February 2012 Product Shipping Configuration Change Notice

This engineering advisory provides details about shipping configuration changes planned for February 2012 to the Polycom® UC Software on Polycom® SoundPoint® IP, SoundStation® IP, SoundStation Duo™, VVX® 500 and 1500 phones, and SpectraLink 8400 Series handsets. This notice is up-to-date as of March 2012. This notice will be updated as new information becomes available.

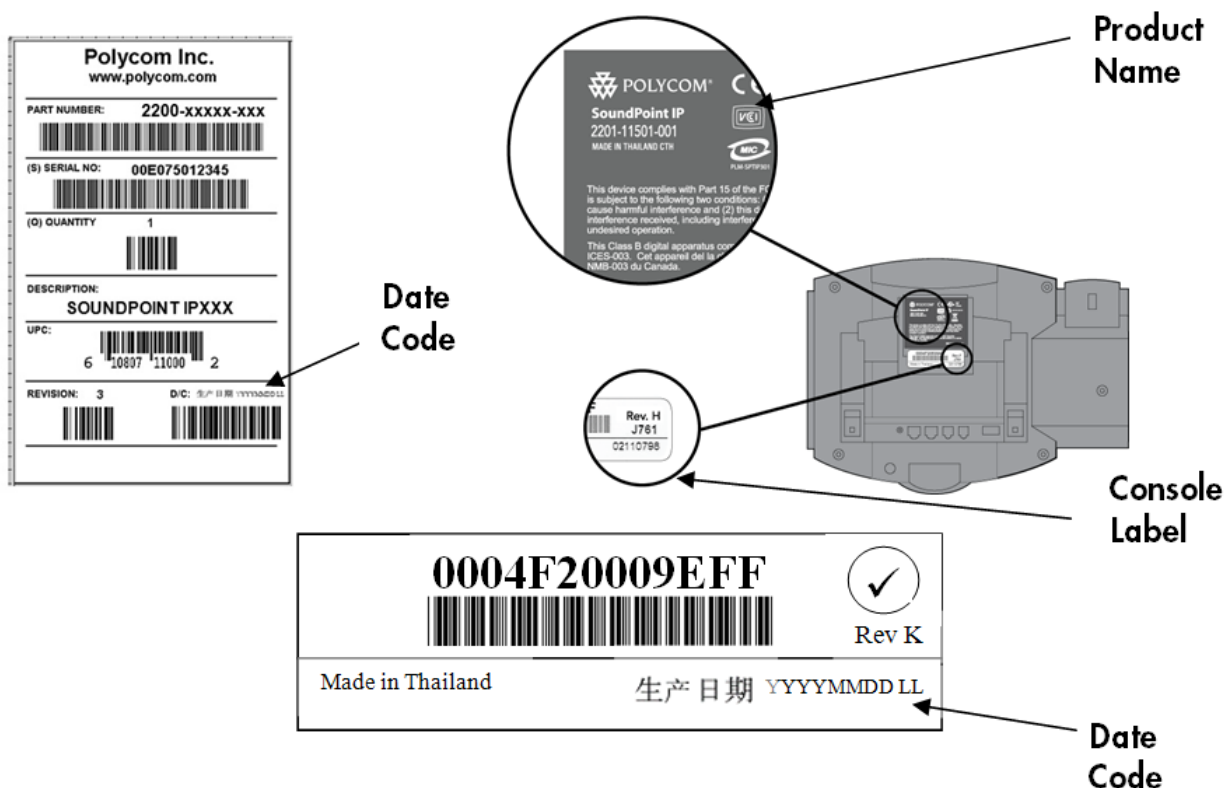
You can determine whether your phone includes the new software by examining the date code listed on the rear of the phone and on the shipping boxes as shown in the following diagrams. This notice will be updated to reflect the actual codes as information becomes available.

The date code starts with the following Chinese characters 生产日期 followed by the date code format YYYYMMDDLL, indicating when the phone was built. (The suffix LL indicates the manufacture location.)
